APPLICATION NO.	FILING DATE	FIRST NAMED INVENTOR	ATTORNEY DOCKET NO.	CONFIRMATION NO.
10/597,205	07/17/2007	Carsten Heldberg	713-1429	7730

Office Action Summary	Application No. 10/597,205	Applicant(s) HELD BERG ET AL.	
	Examiner JONATHAN BRADFORD	Art Unit 3744

DETAILED ACTION

Saur

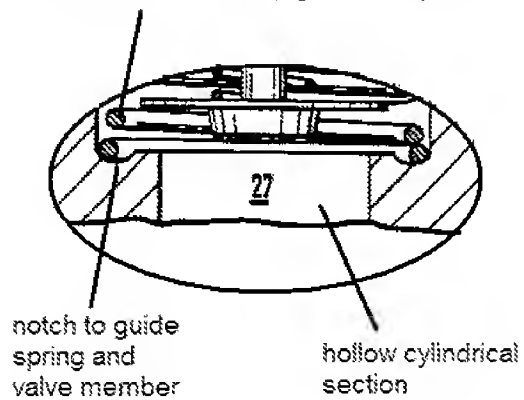
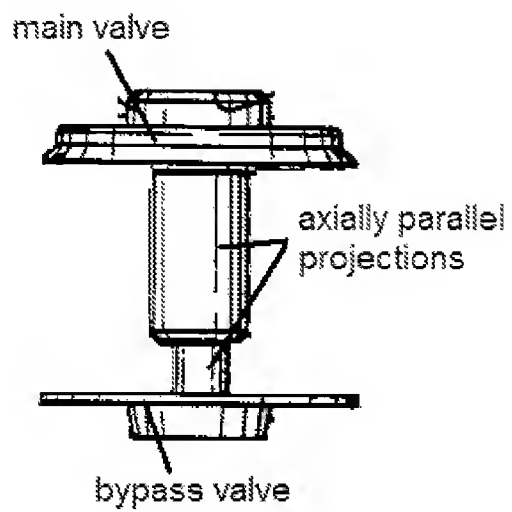
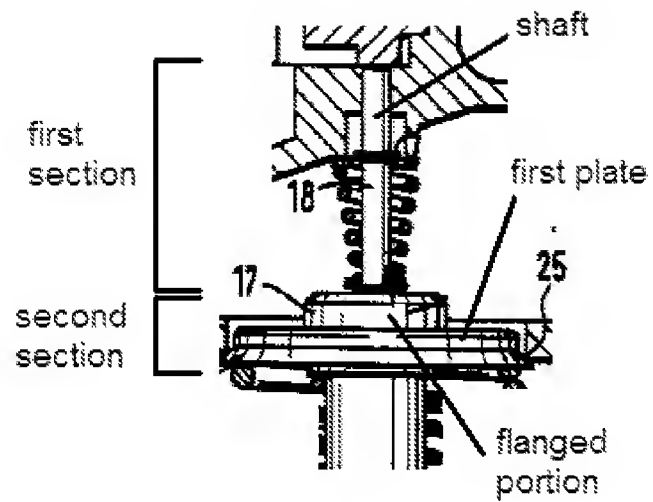
circuit of the engine; and a valve spring 12 that is between the main valve member 6 and the guide component and surrounds the expansion element and the entire hollow cylindrical section of the guide component (see annotated figures), wherein when the main valve member 6 is closed, the main valve member is biased by the valve spring 12 to be directly engaged with the main valve seat 25 and the bypass member 7 is disengaged from the hollow cylindrical section of the guide component (as shown in Fig. 1), and when the main valve member 6 is open, the main valve member 6 is pressed by an expansion of the expansion element and disengaged from the main valve seat 25 and the bypass valve member 7 is pressed by the expansion element into the hollow cylindrical section of the guide component (col. 4, lines 1-13).

As to claim 15, Saur, as modified, teaches a main valve member 6 which is connected to the bypass valve member 7 by parallel projections which extend axially (see annotated figures).

As to claim 12, Saur, as modified, teaches a main valve member 6 formed from a first plate and a second plate coaxially connected to the first plate (see annotated figures). Saur, as modified, does not explicitly teach a sealing ring sandwiched between the plates that is directly engageable with the main conical sealing valve seat. However, Griffin teaches using a sealing ring 60 sandwiched between two coaxially connected plates 40 and 46 to seal against conical valve seat. It would have been obvious to a person having ordinary skill in the art, at the time of the invention, to further modify the valve member 6 of Saur to include a sealing ring sandwiched between the coaxially connected plates as taught by Griffin, because it would prevent the valve from being

As to claim 14, Saur, as modified, teaches an expansion element with a shaft 18 at the first section which faces the main valve seat, while a flanged second section is received in a complementary recess of the first plate (see annotated figures.)

spring surrounding notch and cylindrical section which make up guide component

The applicant argues that the applied art fails to disclose or suggest the amended feature of a valve spring that surrounds the entire hollow cylindrical section of the guide component. The examiner respectfully disagrees. Fig. 1 of Saur shows a valve spring 12 which surrounds the entire circumference of the hollow cylindrical section 27. Therefore the spring is considered to meet the limitation as it surrounds the circumference of the cylindrical section in its entirety.

Henschel

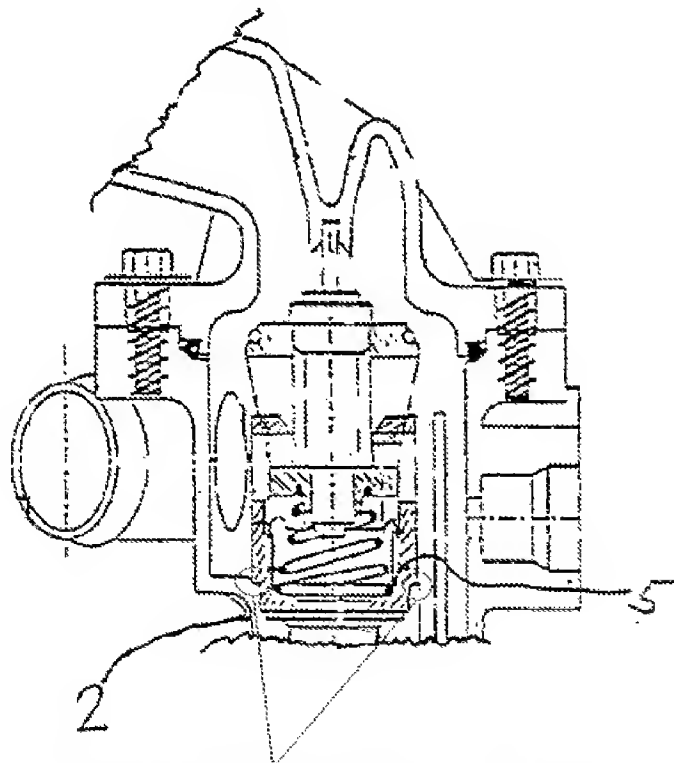
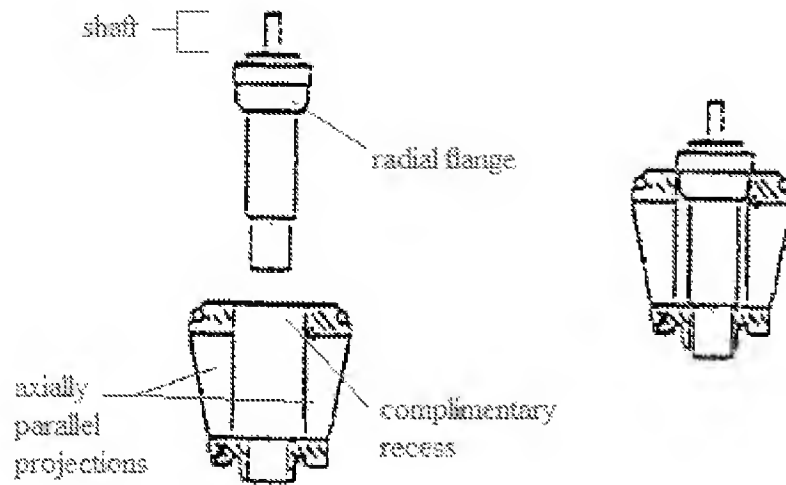
As to claim 25, Henschel, as modified, teaches an expansion element comprising a shaft at the first section facing the main valve seat and a radial flange at the second section received in a complementary recess of the valve member which faces the flange (see annotated figure).

As to claim 26, Henschel, as modified, teaches connecting the main valve member with the bypass valve member with axially parallel projections (shown in annotated figures).

As to claim 27, Henschel, as modified, includes a valve member equivalent to first and second plates as stated in the rejection of claims 23-24 above. Further, the lower portion of the main valve member (analogous to a "second plate") is connected with the bypass valve member via the projections and the elements form an integral component (see annotated figures).

As to claim 30, Henschel teaches a guide component 5 that has an annular rib which fits securely into an annular groove of the lower portion 2 that supports the guide component (see annotated figures).

Annular rib of guide component 5 fits securely into an annular groove of the lower portion 2 which supports the guide component
